March 19, 2019

Project No. 12091-01

**Subject: Preliminary Geotechnical Evaluation and Response to City Review Comments for Proposed San Pedro Distribution Center, 1599 W. John S. Gibson Boulevard, Los Angeles, California**

SHEET 3  
SHEET 2

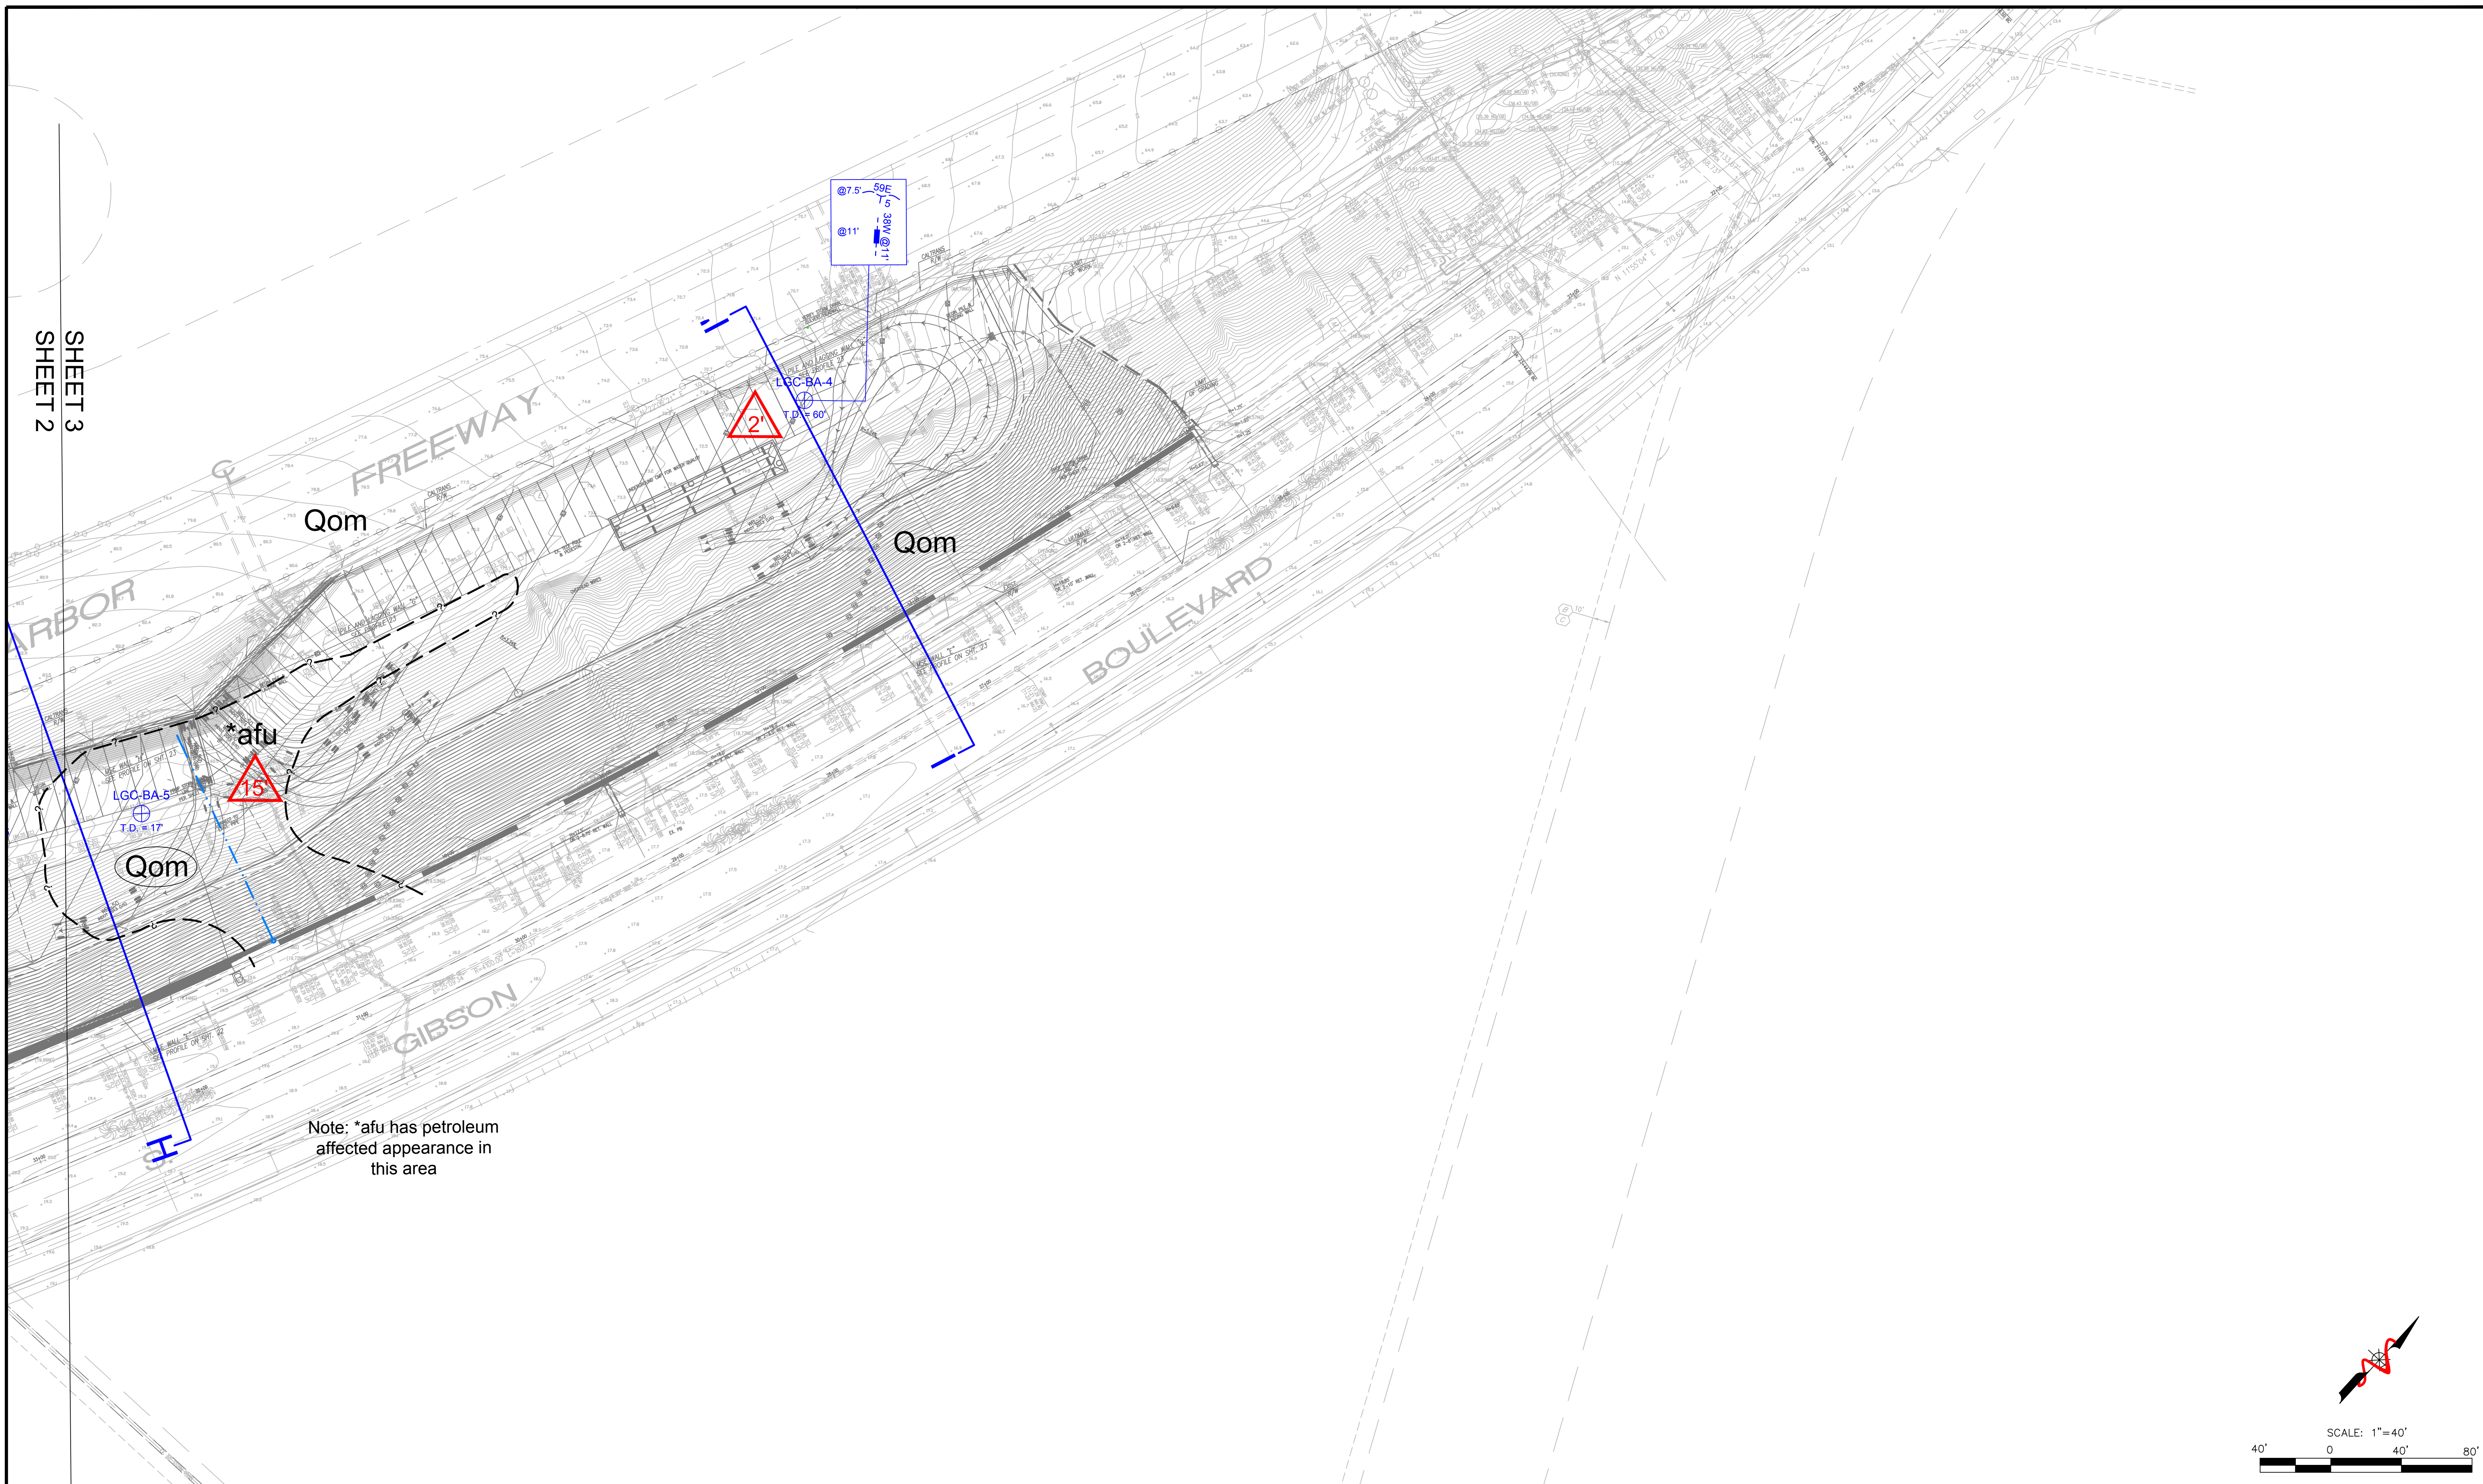
“No map was provided with the current update report reflecting the proposed site conditions. Provide recommendations and revise the plan(s) and cross sections(s) for providing the required building setback from the toe of the ascending slope as specified by Code Section 1808.7.1.”

Refer to the attached Geotechnical Map (Sheets 1 through 3). No building structures are planned for the site.

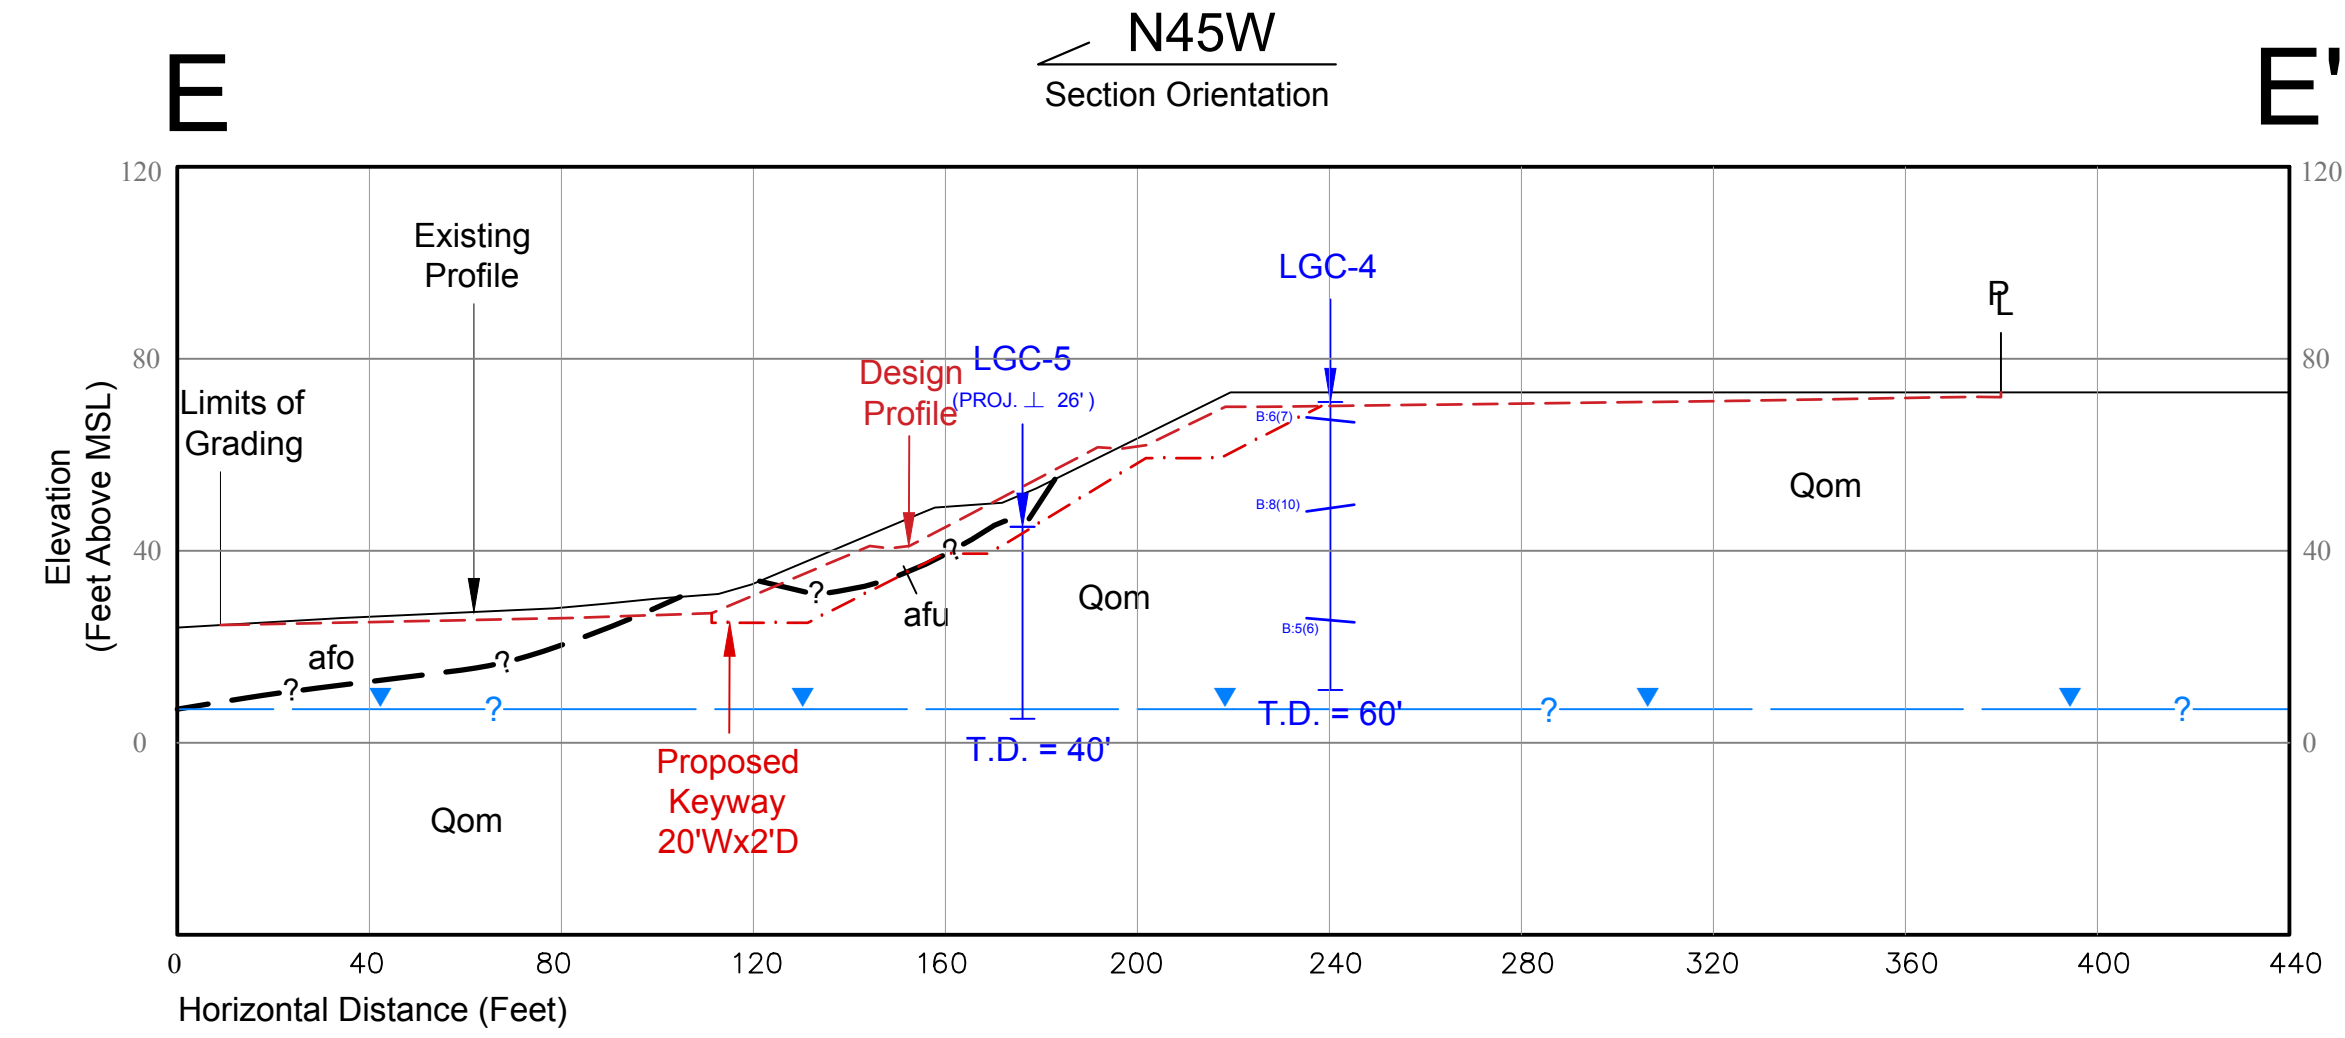
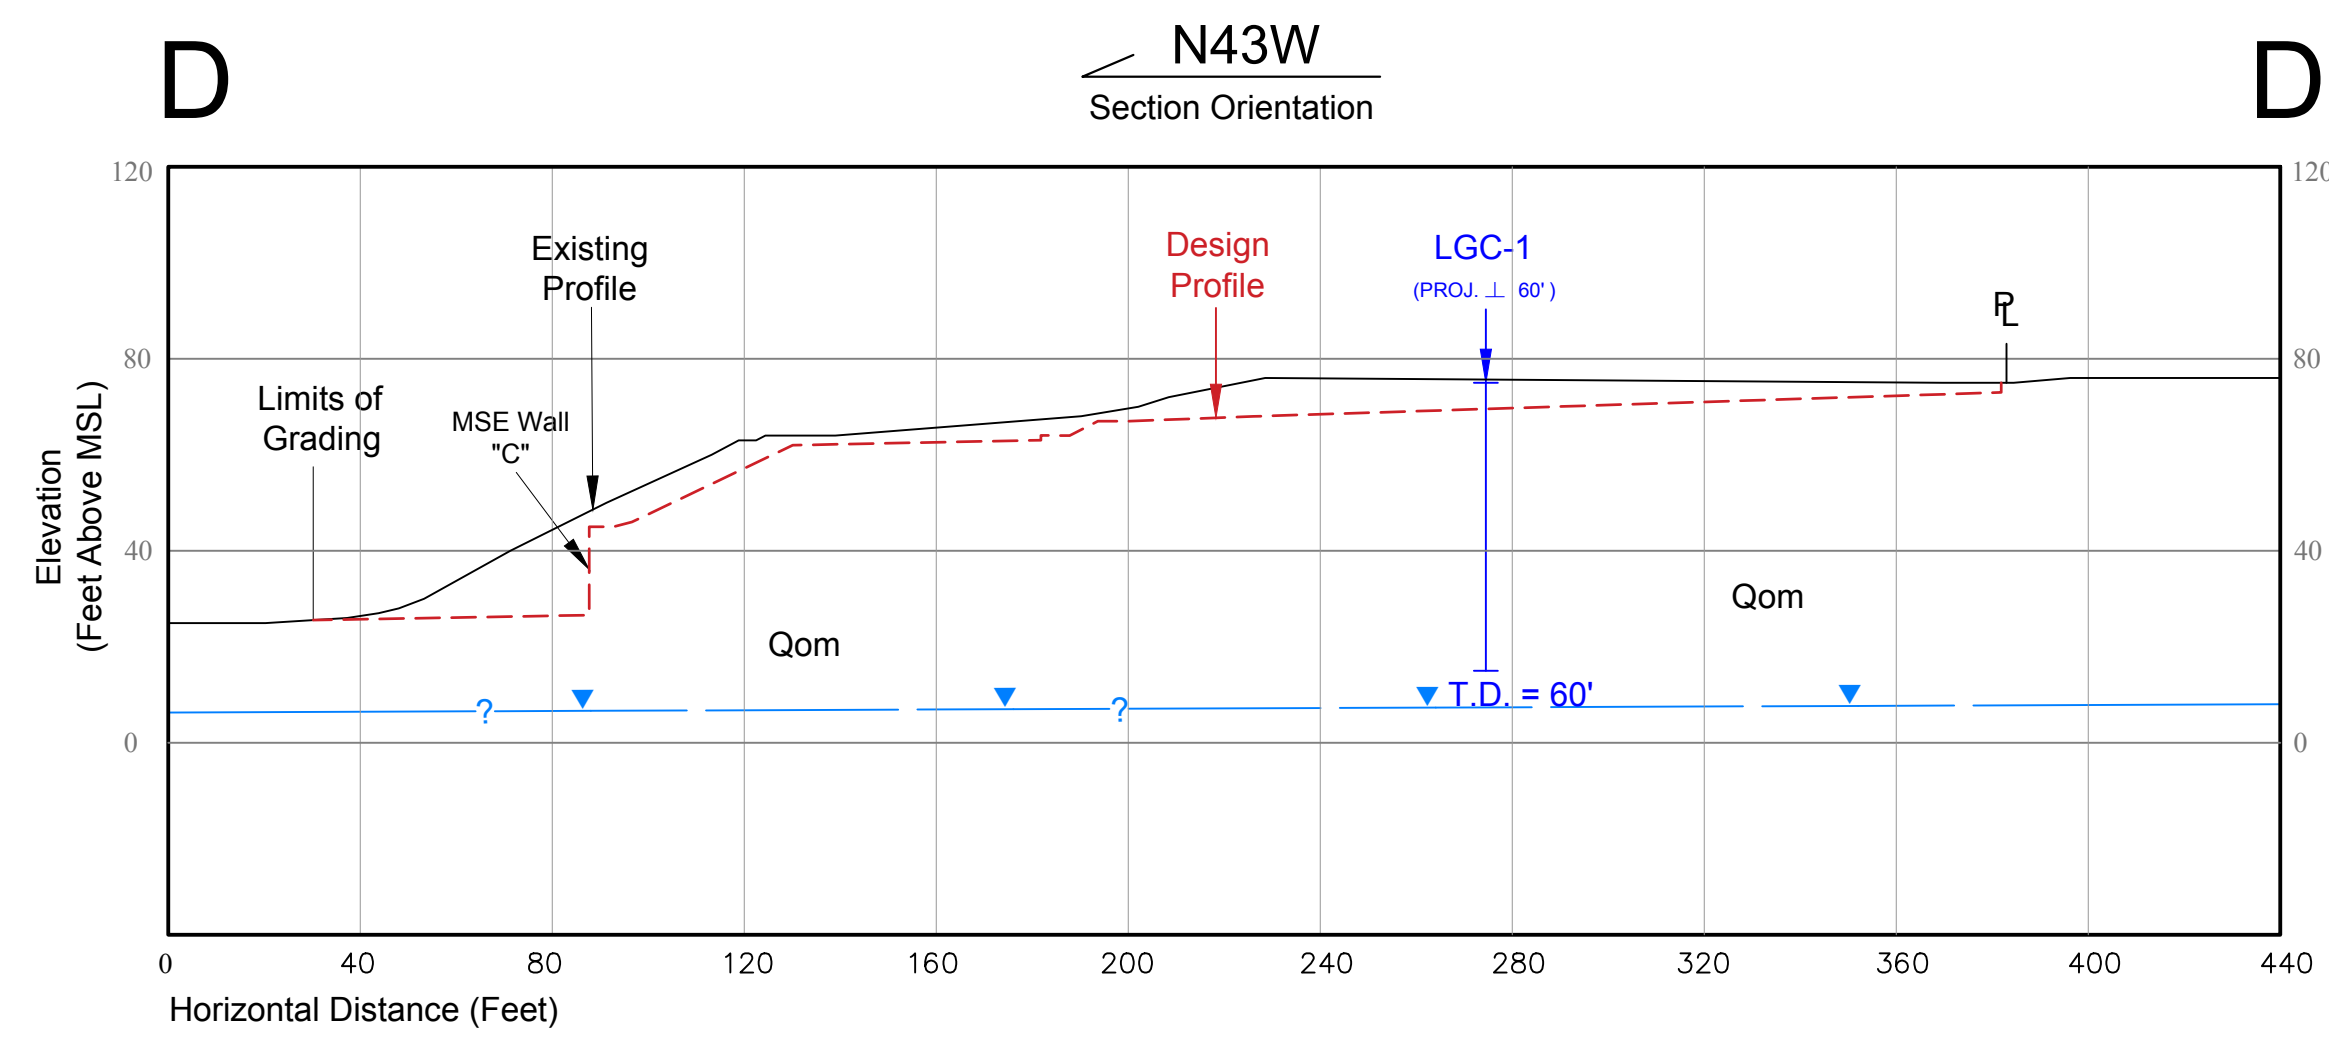
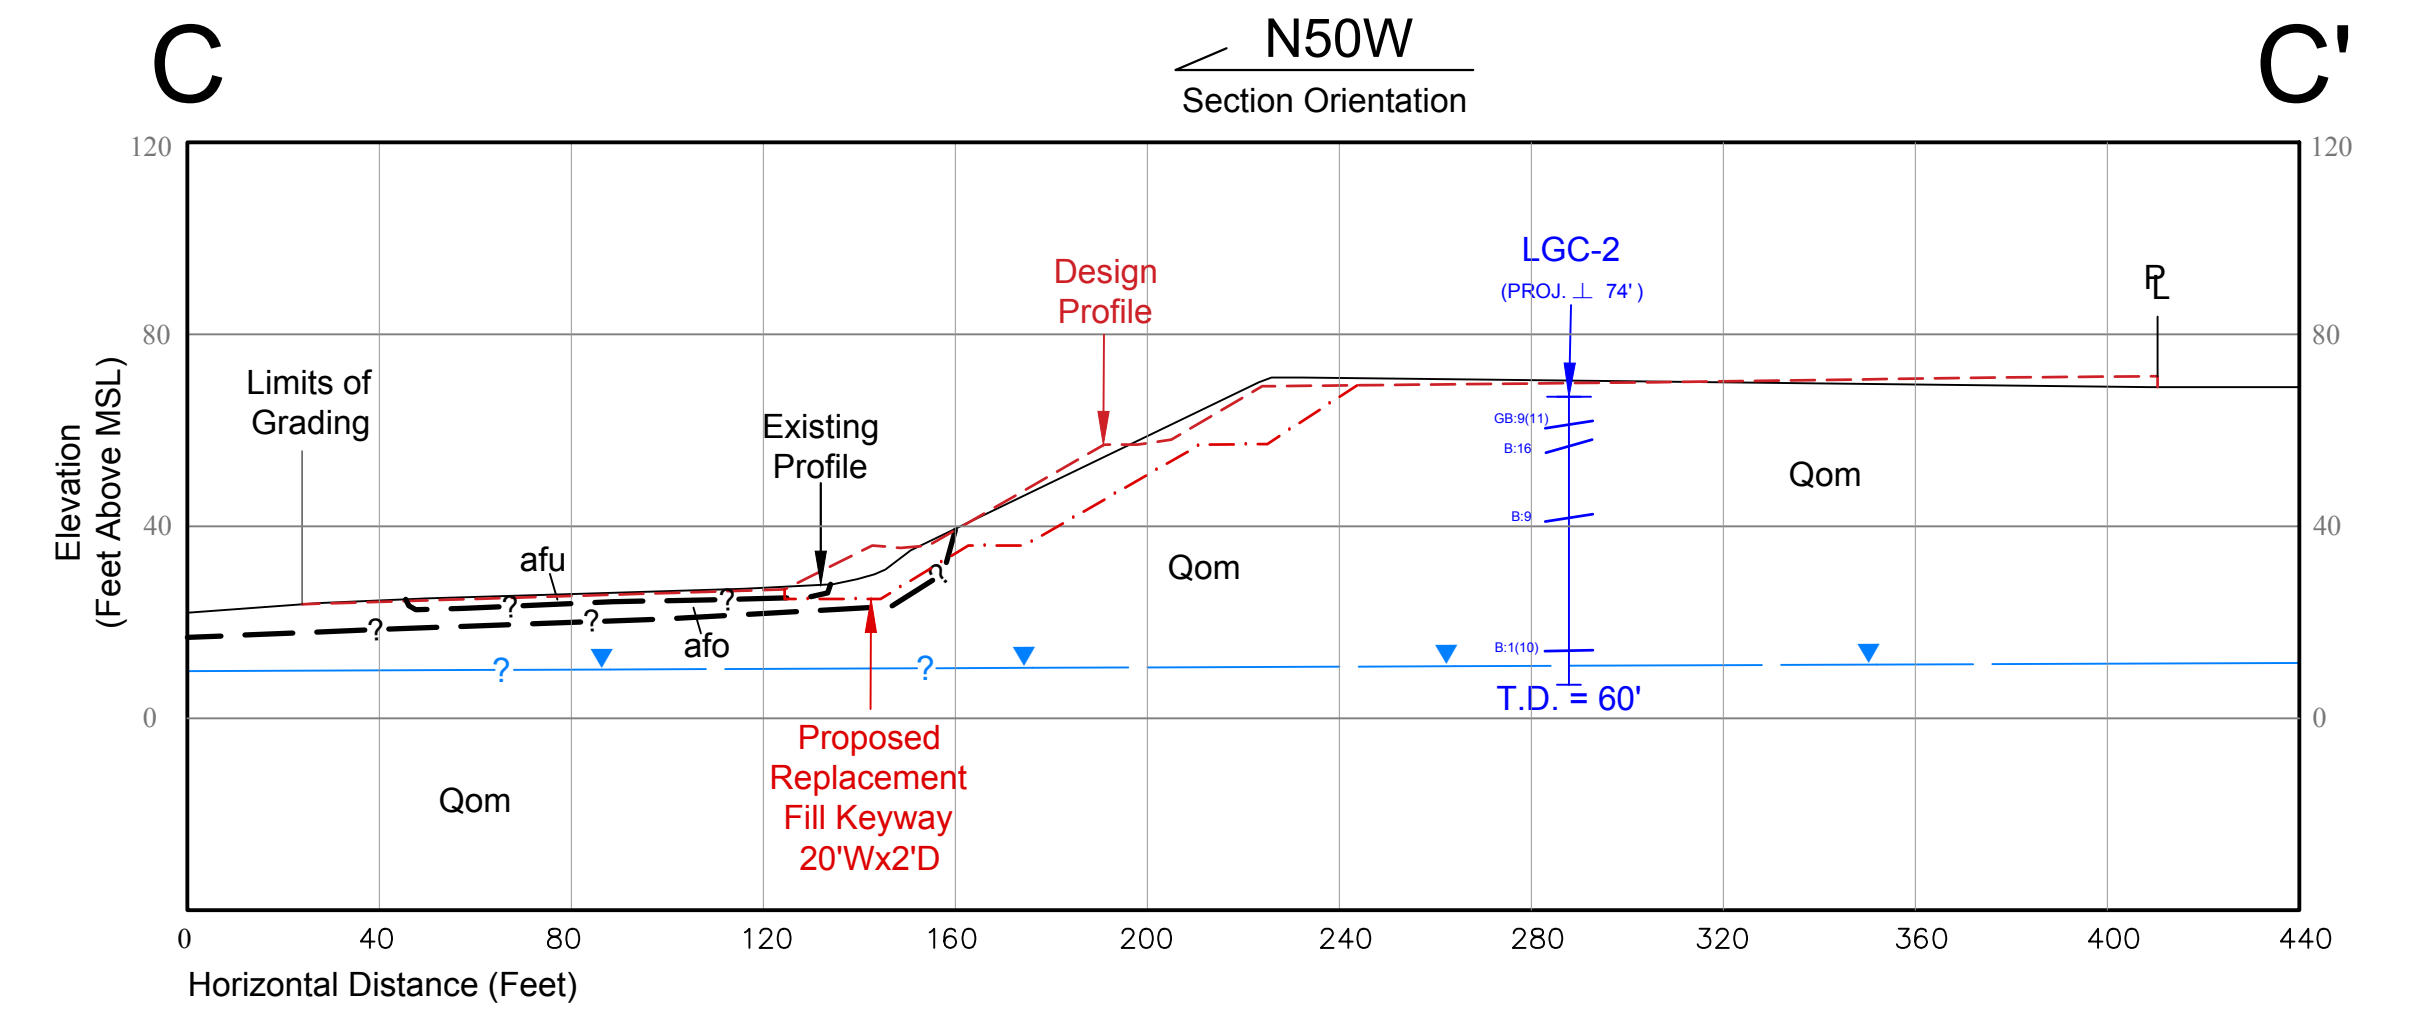
“Provide a geologic map and cross sections that are based upon conceptual grading or site development plans, to illustrate all proposed and existing contours relative to the planned grading and/or construction, along with all off-site slopes and conditions that could adversely affect the stability or safety of the site (7006.3.2). The geologic map and cross sections shall depict the top and bottom of slopes; lithologic contacts; bedding attitudes; locations of slumps, landslides, or faults relative to the subject site; existing and proposed topographic profiles; existing and proposed structures; and, required Code setbacks. (7006.3.2)”

“Provide geological cross sections illustrating existing and proposed grades and structures through the highest, steepest and geologically critical slopes.”

Refer to the attached Geotechnical Map and Geotechnical Cross Sections (Sheets 1 through 5). No building structures are planned for the site.
